# Modification Report

Westlink Industrial Estate – Stage 1 (Modification 2)

SSD-9138102

**Figure 5 Approved and Proposed Trunk Drainage Channel**

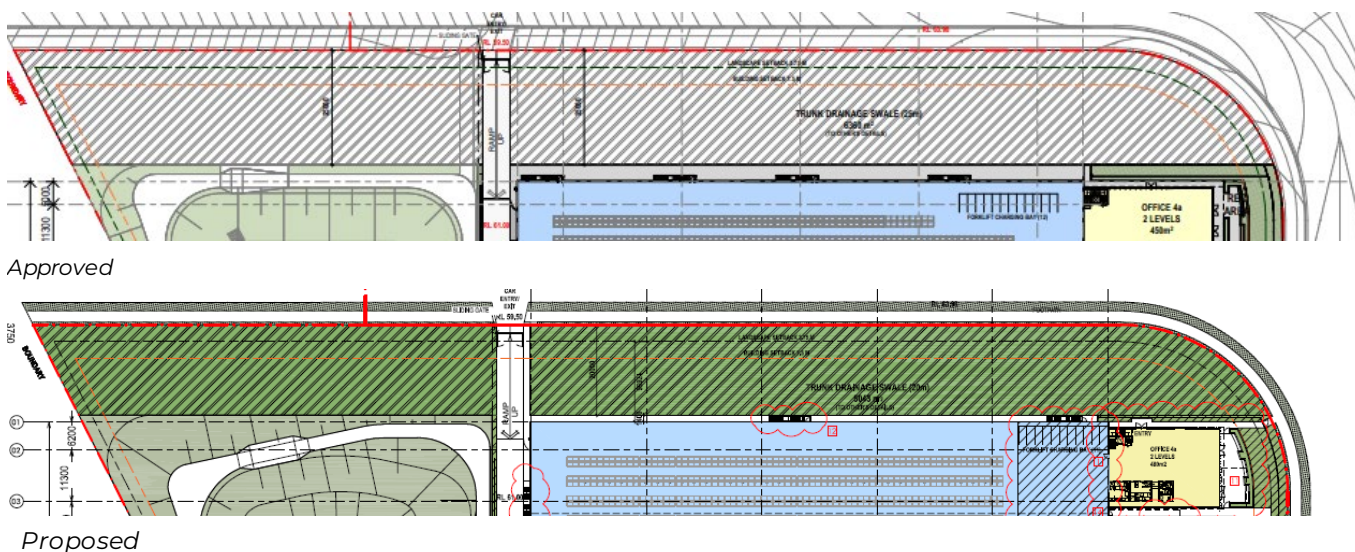
The Applicant and J. Wyndham Prince (Civil Engineer) have subsequently consulted with Sydney Water and achieved an acceptable trunk drainage channel design (refer to **Appendix H**). The approved development comprised a 25m wide trunk drainage swale that runs along the northern boundary of Lot 4. However, as part of the detailed design of the trunk drainage channel, which included consultation with Sydney Water, it has been determined that the design criteria can be satisfied by a 20m wide trunk drainage channel.

A comparison of the trunk drainage channel as approved and proposed to be modified in **Figure 7** below.

**Figure 6** Approved and Proposed Warehouse 4 Site Plan

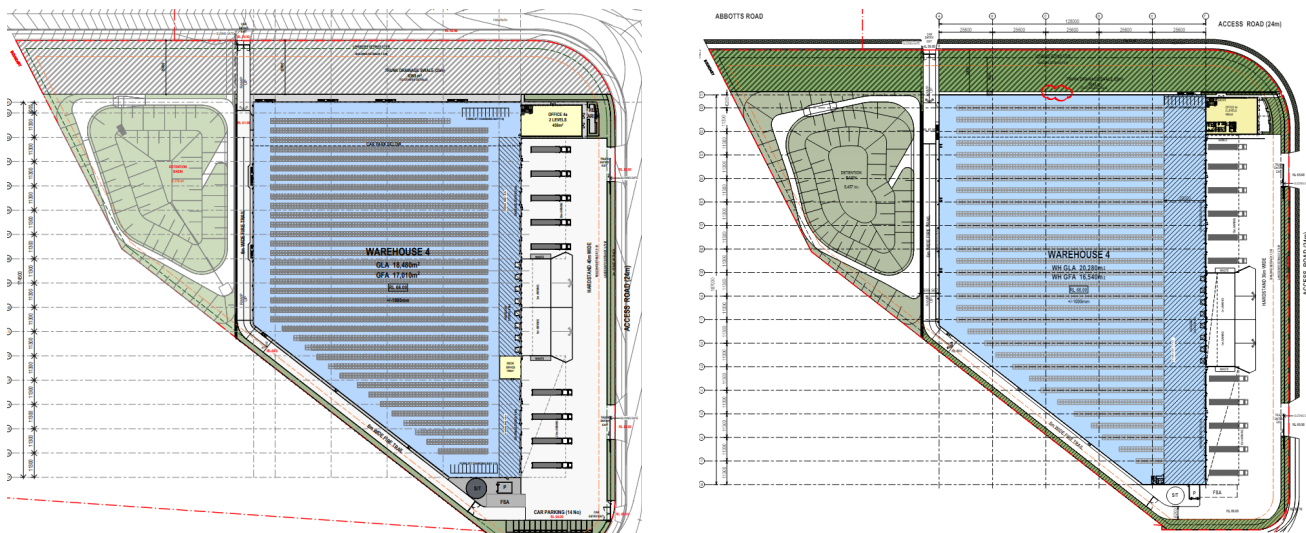
As a result of the reduction in width of trunk drainage channel and ongoing design development in consultation with the future tenant, Warehouse 4 is proposed to be modified. The proposed changes include an increase in the overall floorspace of the building due to the proposed reduction in trunk drainage channel width.

The proposed changes also include an increase in the loading zones area from 1,470m<sup>2</sup> to 3,630m<sup>2</sup> as a result of ongoing design development with the future tenant. As such, the proposed changes include an overall reduction in the total GFA from 17,460m<sup>2</sup> to 17,020m<sup>2</sup>.

The ancillary office GFA is proposed to increase slightly by 30m<sup>2</sup> with Office 4A being shifted further north to also align with reduced trunk drainage channel width. The modified Warehouse 4 also reduces the number of car parking spaces from 96 to 85 and increases the number of loading docks from 17 to 19. The undercroft car park egress has also been amended slightly to accommodate BCA requirements. A comparison of the Warehouse 4 Site Plan as approved and proposed to be modified is provided in **Figure 8** below.

**Figure 7** Approved and Proposed Lot 4 Detention Basin

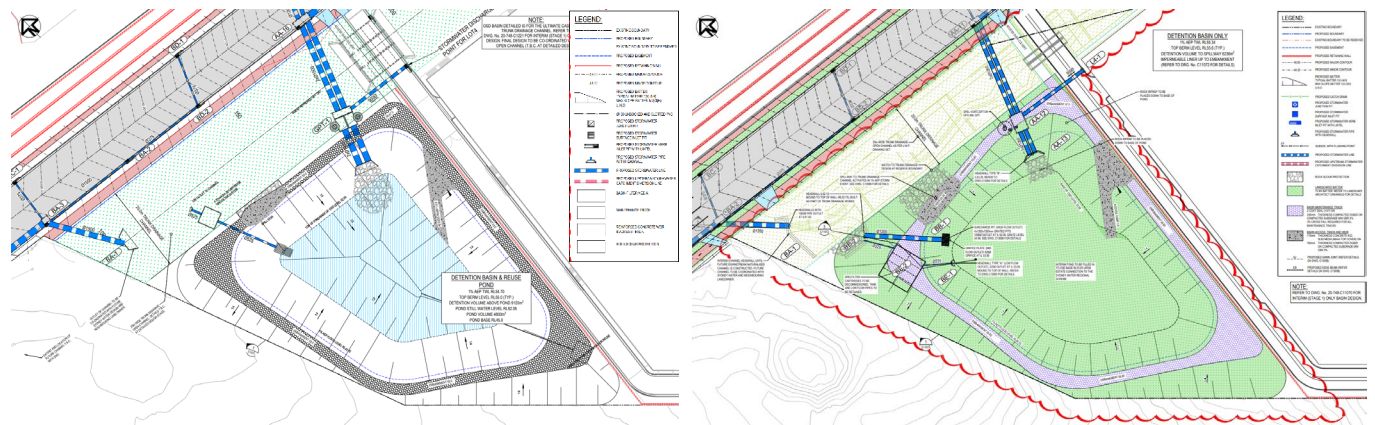
As a result of the reduction in width of the trunk drainage channel, the Lot 4 Detention Basin has also been modified to meet the trunk drainage channel, as illustrated in **Figure 9**. It is noted that the amended Estate Civil Drawings (**Appendix D**) include additional changes to the OSD basin associated with extra details requested by Sydney Water and NSW DCCEEW as part of the satisfaction of Conditions B25 and B30 of the Development Consent. As such, the development remains consistent with the Stormwater Management System Design.

**Figure 8 Approved and Proposed Private Access Road**

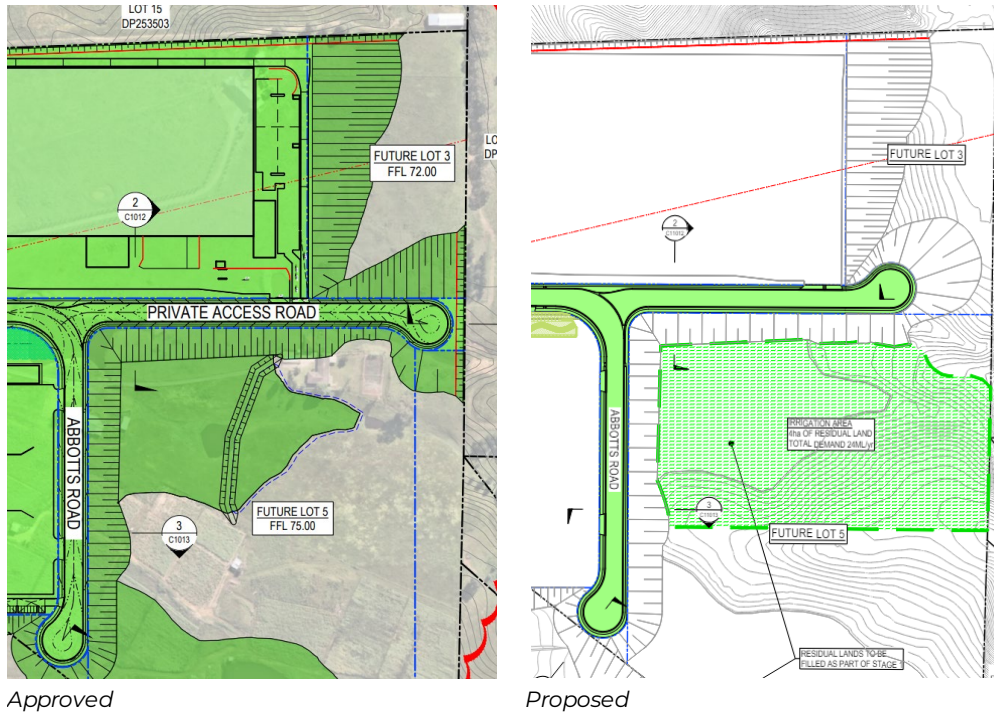
The length of the private access road that connects to Abbotts Road is proposed to be shortened with the turning head also proposed to be reorientated from the south to the north. The eastern end of the private road cul-de-sac has also been adjusted with the cul-de-sac relocated to the west to be suitable for future development on Lot 3. A comparison of the approved and proposed private access road is provided in **Figure 10** below.

**Figure 9 Approved and Proposed Bulk Earthworks Plan**

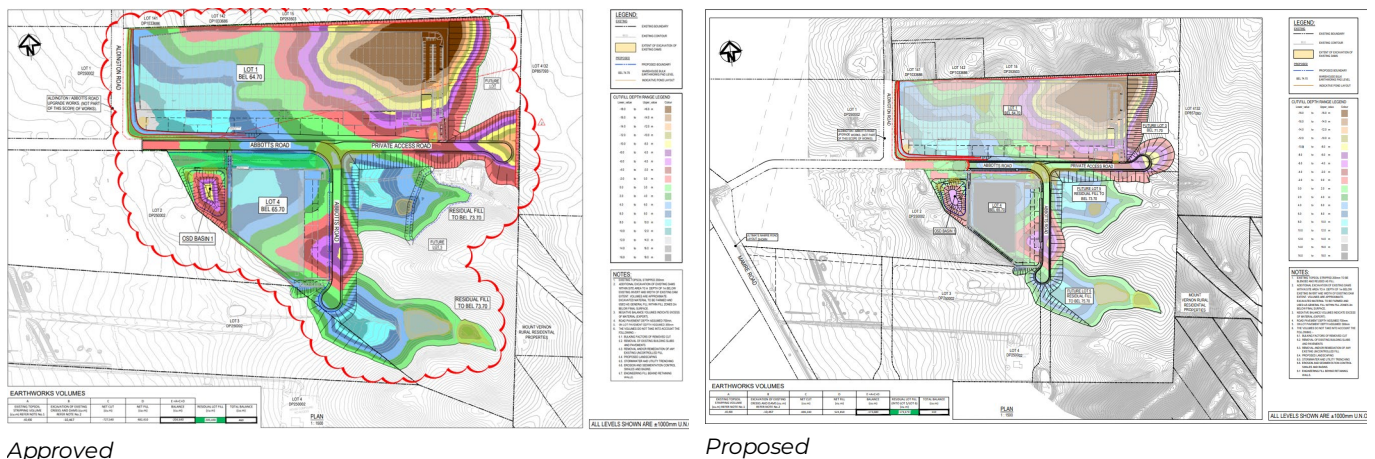
In order to support the proposed changes to the private access road cul-de-sac, changes to the bulk earthworks plan are proposed. A comparison of the approved and proposed Bulk Earthworks Plan is provided in **Figure 11** below.

**Figure 10** Approved and Proposed Interim Stormwater Management Plan

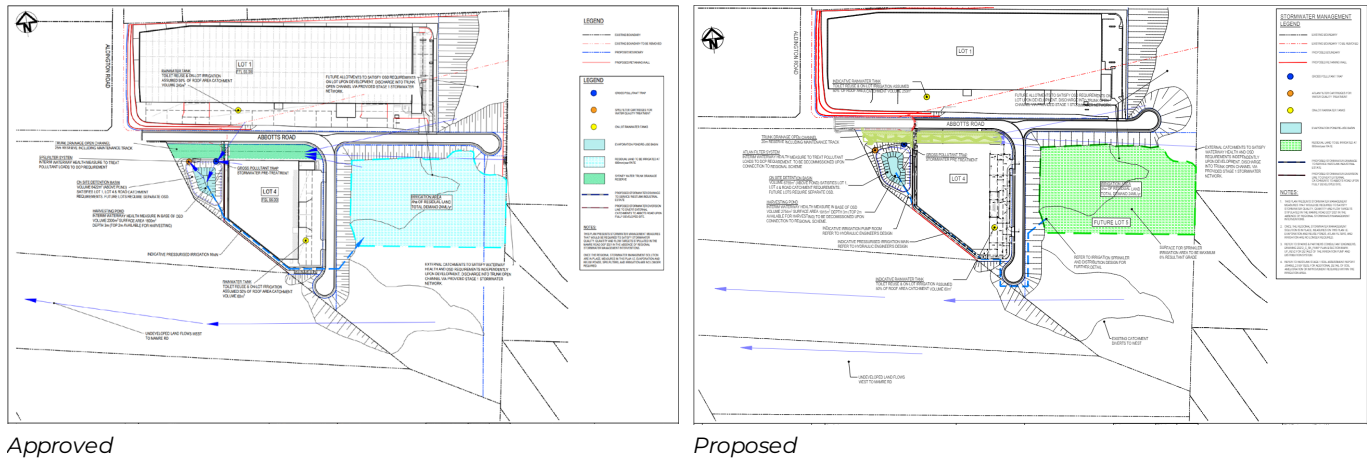
The Stormwater Management Plan (Interim Arrangement) has been amended with the designated irrigation area proposed to be relocated to Lot 3 DP250002 and Lot 4 DP250002. The designated irrigation area is proposed to be relocated to ensure waterway health targets are met in the interim prior to Sydney Water’s regional basins being available.

A comparison of the approved and proposed Interim Stormwater Management Plan is provided in **Figure 12** below.
